USNRDL-TR-582
17 September 1962

DESIGN MODIFICATIONS AND 1962 COST ANALYSIS
FOR A STANDARDIZED SERIES OF FALLOUT SHEILDERS

prepared for the
OFFICE OF CIVIL DEFENSE
DEPARTMENT OF DEFENSE

U. S. NAVAL RADIOLOGICAL DEFENSE LABORATORY
S A N F R A N C I S C O 2 4 . C A L I F O R N I A

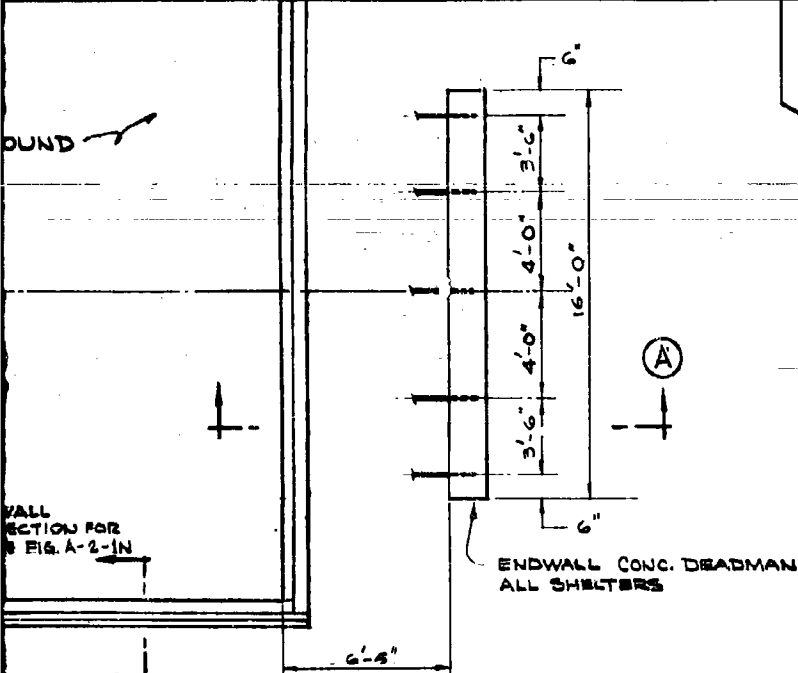
2. The expansion joint filler now specified (Fig. A-2M) is just as adequate as that formerly specified in Ref. 1, but it is less costly.

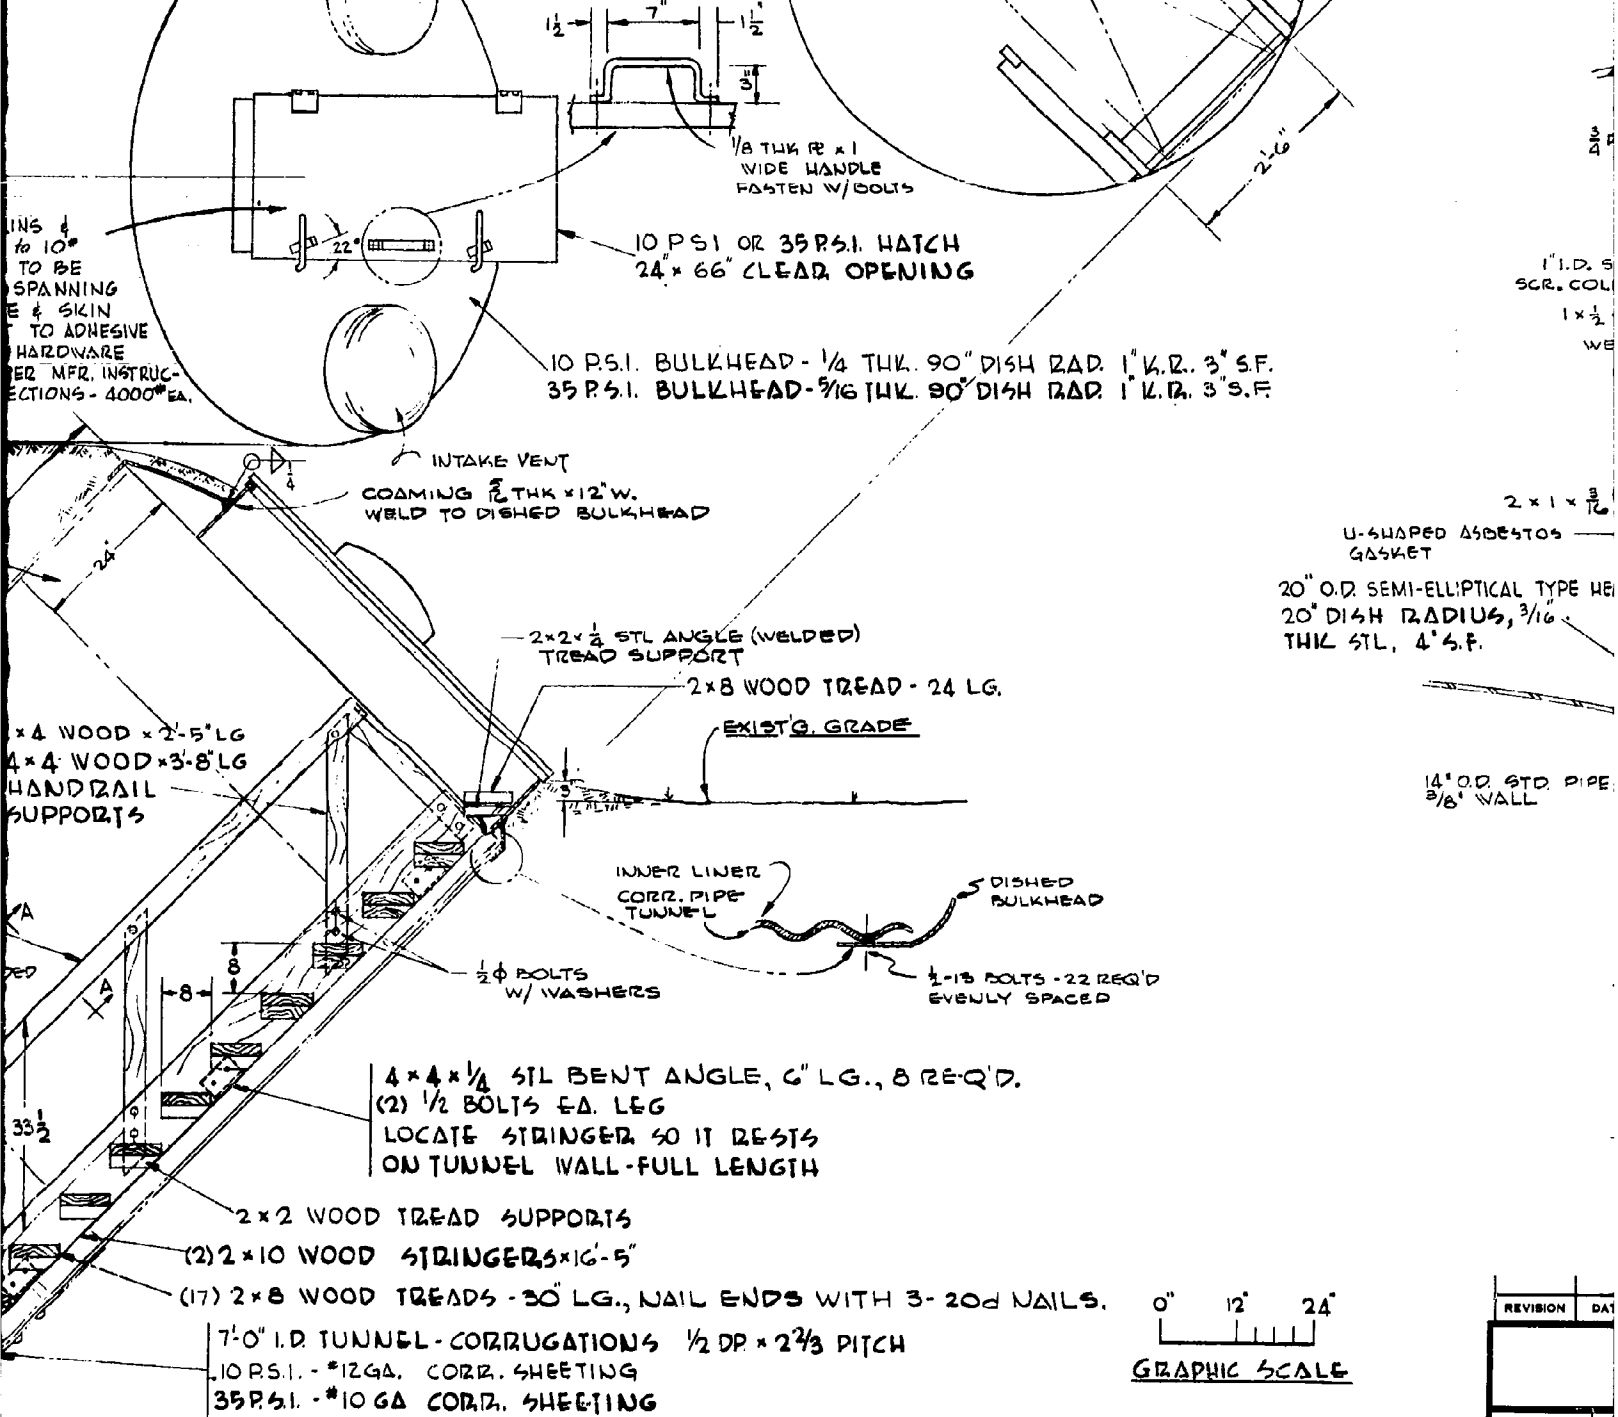
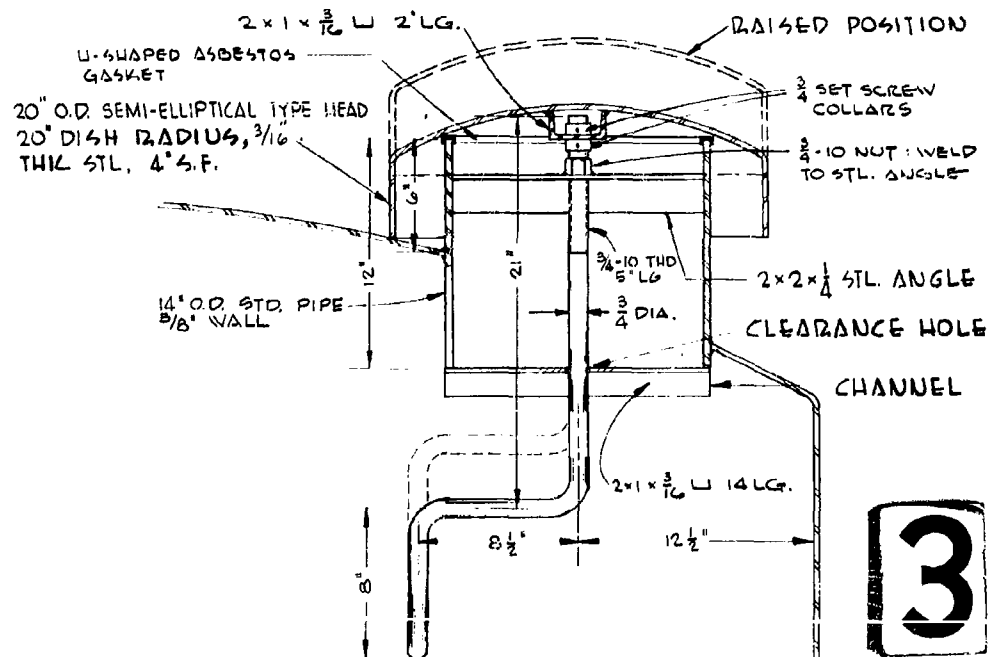
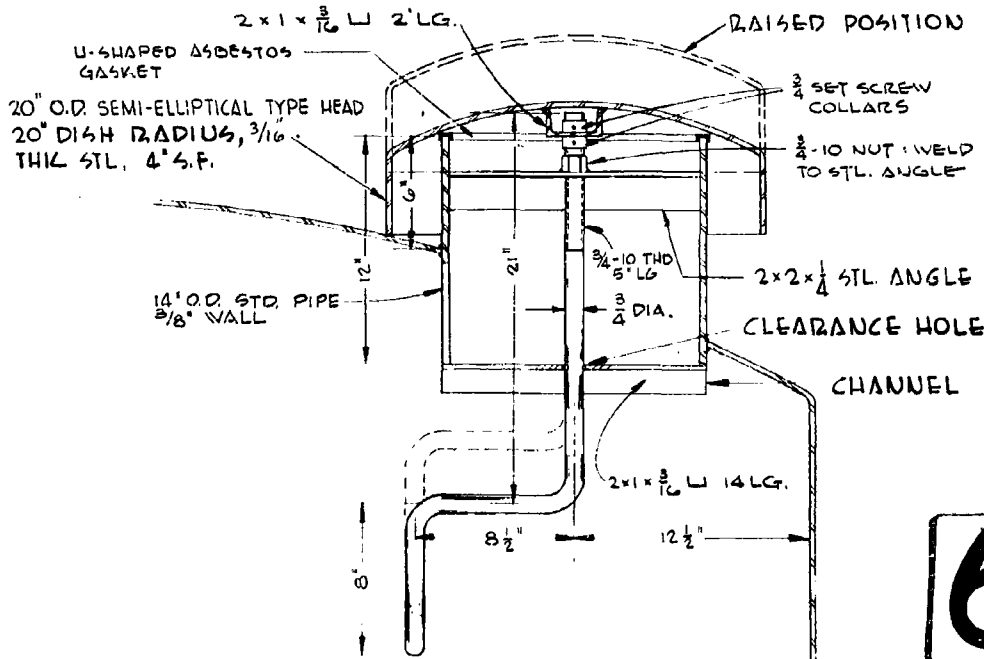
3. Notes have been added to the drawing (Fig. A-3M) on entrance and endwall support details specifying (a) the base metal to be used in fabricating the basic arch structure, the endwalls, and the entranceway; (b) the manufacturing tolerances; (c) the erection procedure to be followed by the contractor; and (d) the basic quality control of workmanship in fabrication and erection.

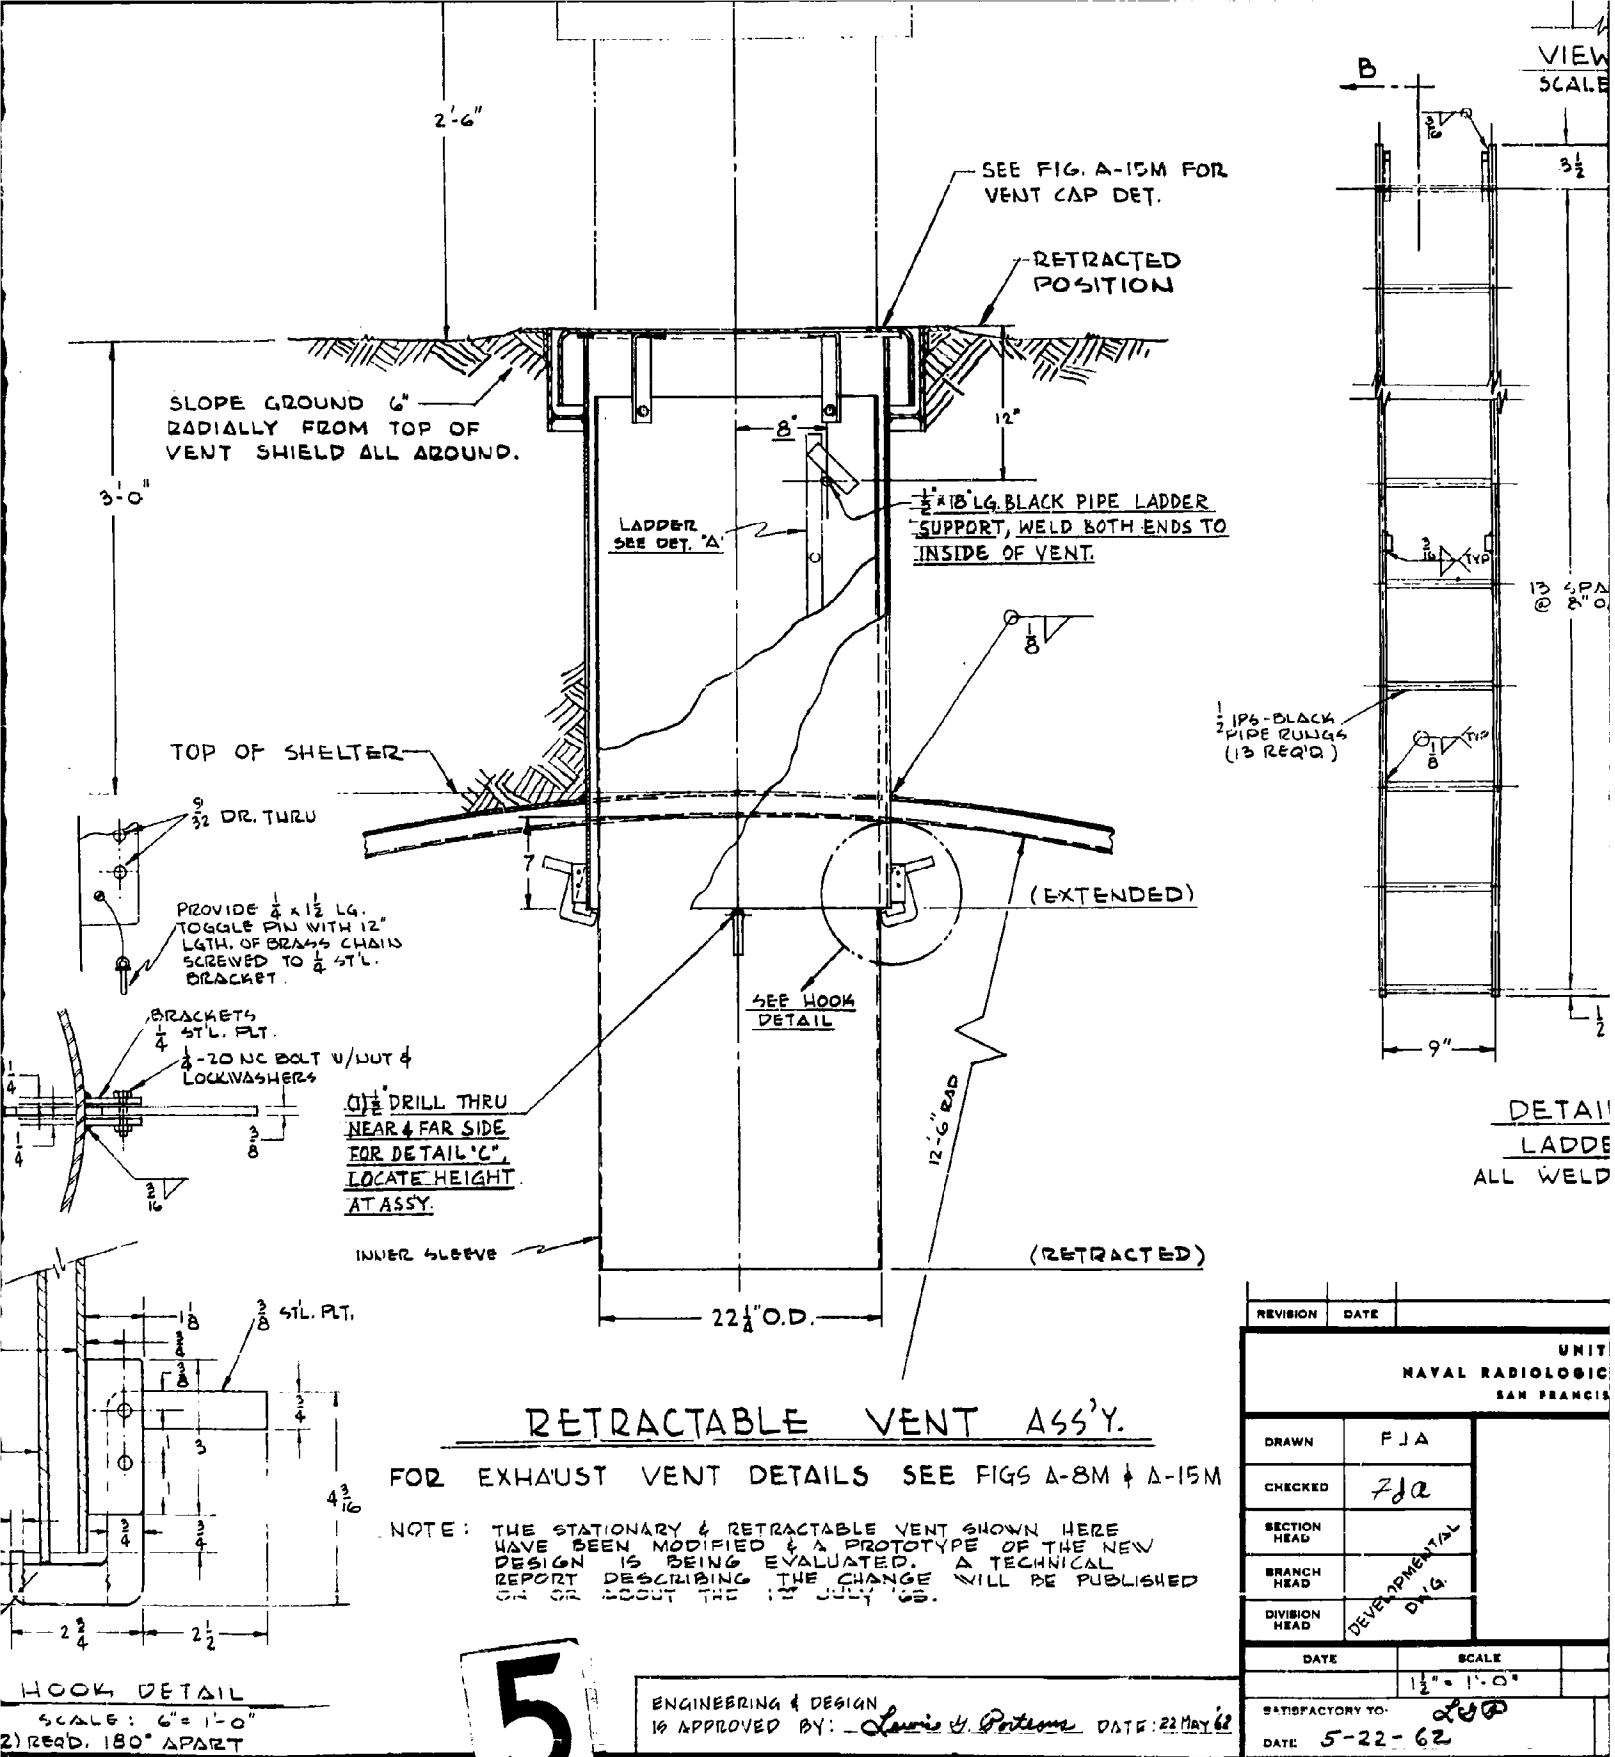
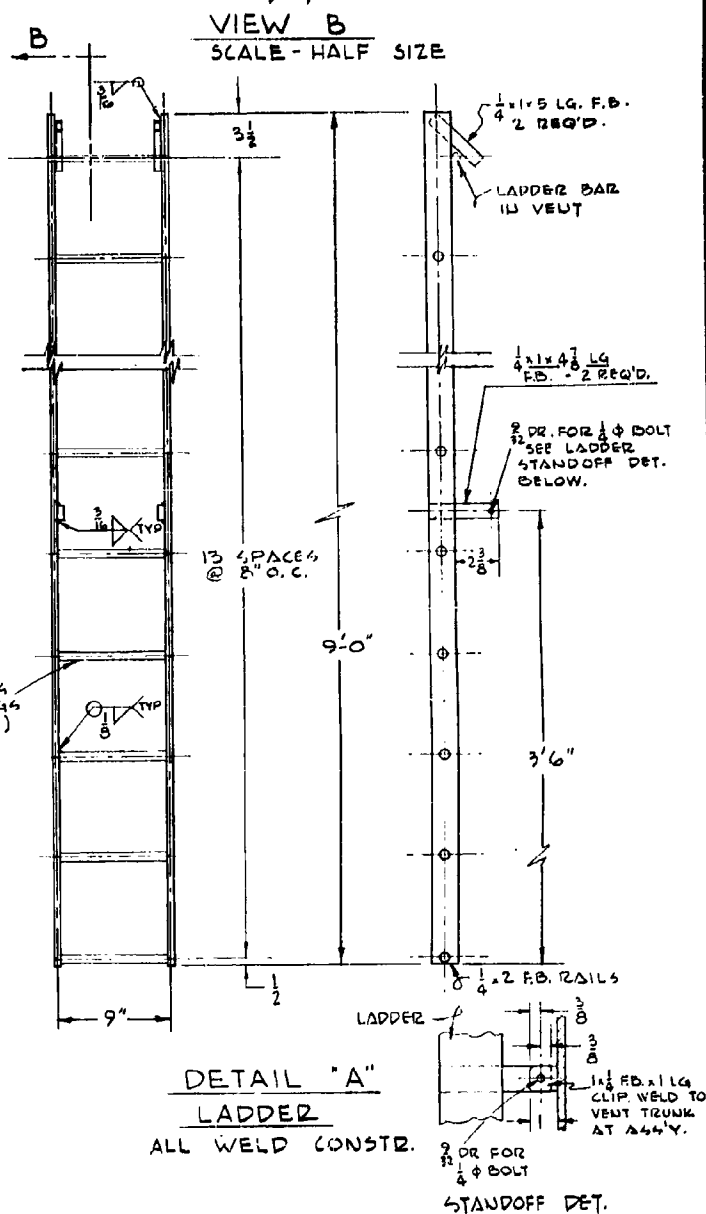
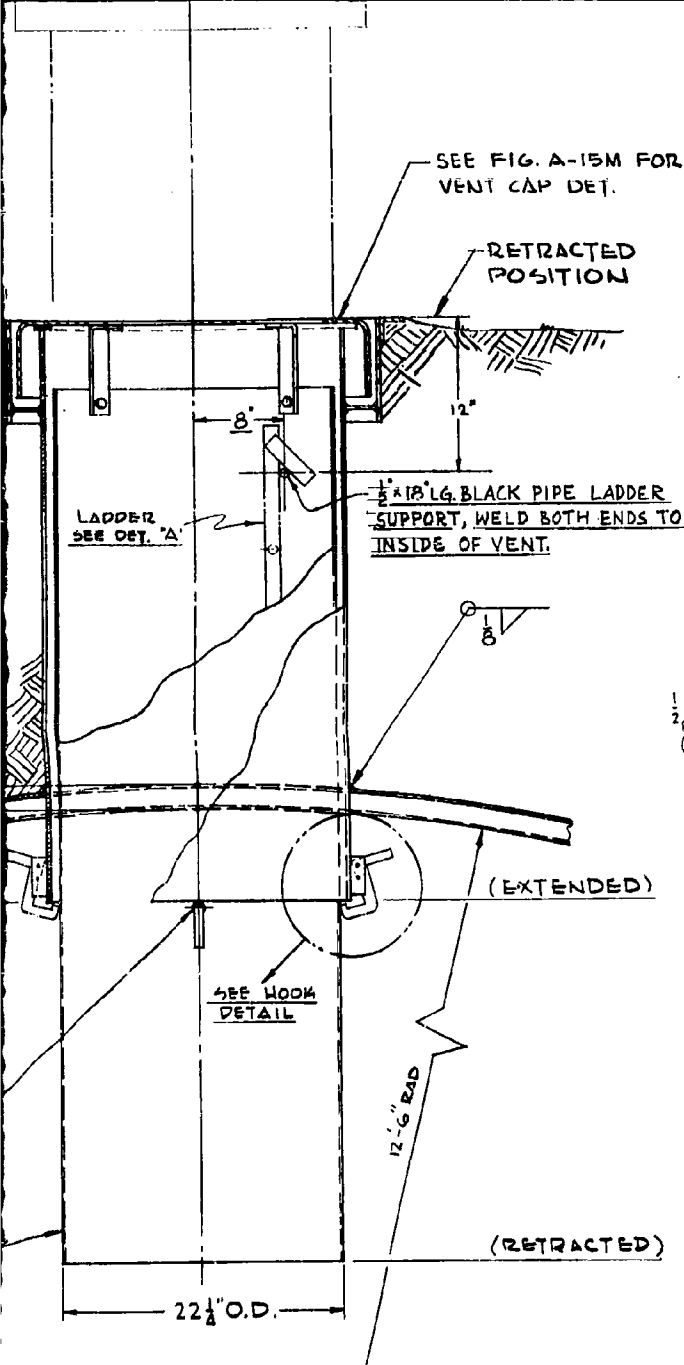
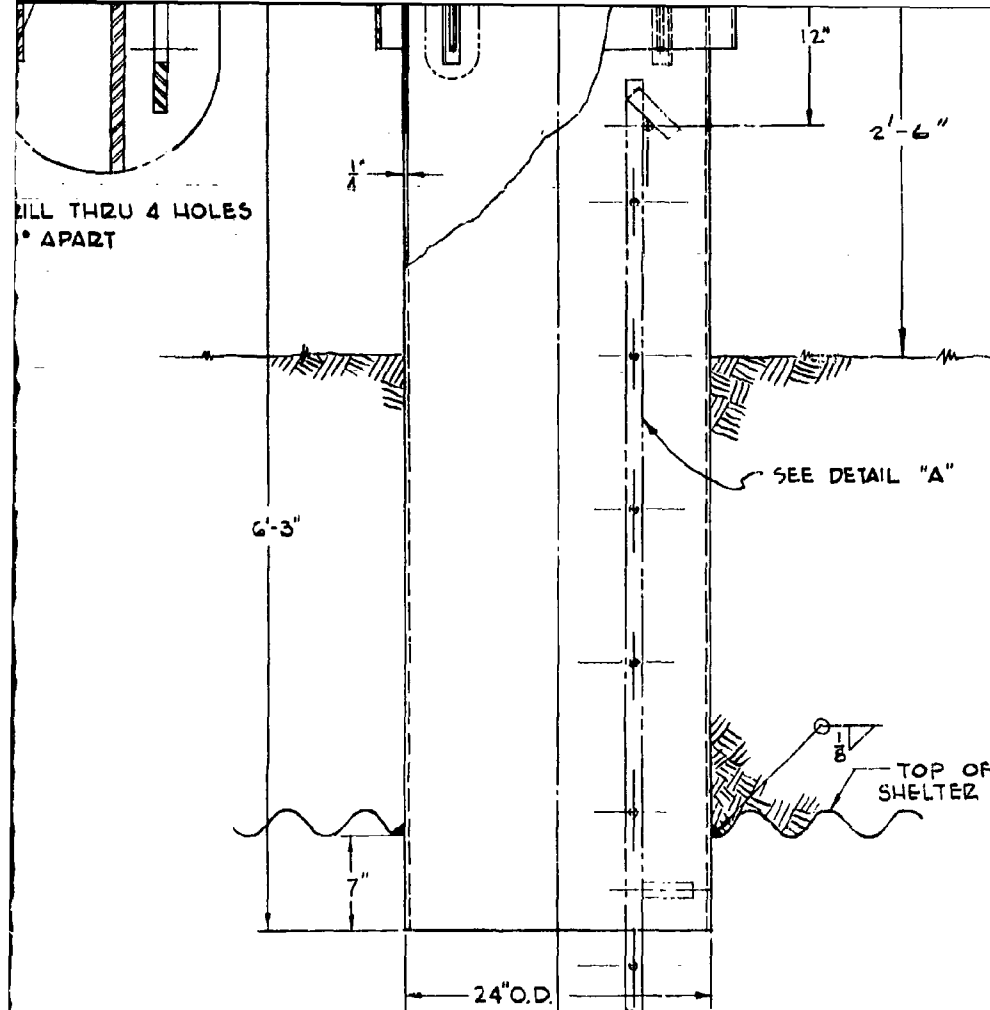
Minor modifications have been made in the exhaust vent design to reduce costs. Refer to Figs. A-7M and A-8M for details.

STATIONARY & RETRACTABLE VENT SHOWN HERE HAVE BEEN MODIFIED & A PROTOTYPE OF THE NEW DESIGN IS BEING EVALUATED. A TECHNICAL REPORT DESCRIBING THE CHANGE WILL BE PUBLISHED OR ABOUT THE 15 JULY 62.
